Product Change Notification

1. ECR #: 222550
Notification #: 686

- ADM6 - ADM6 ASSEMBLY

NEW 0.016" SOLDERBALL SIZE

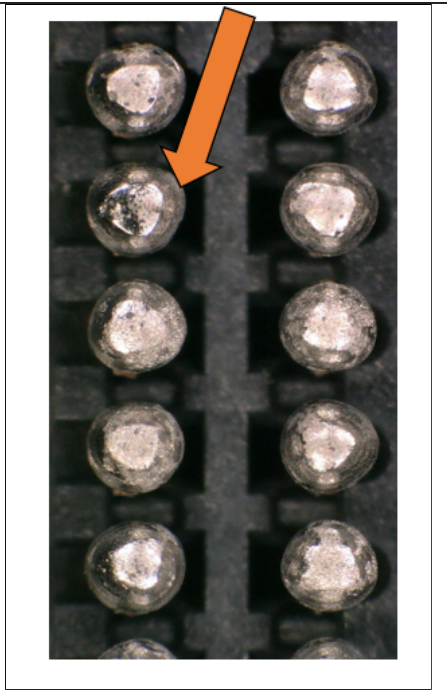
The ADM6 product series will utilize a 0.016" solderball diameter size in place of the current 0.018" solderball diameter size. Old revision material will be used until its supply is depleted. There is no change to the recommended PCB layout for the ADM6 series. The mating ADF6 product series will also utilize a 0.016" solderball diameter size in place of the current 0.018" solderball diameter size.

The current ADM6 product uses an 0.018" solderball diameter size. In contrast, the updated ADM6 product will use a smaller 0.016" solderball diameter.
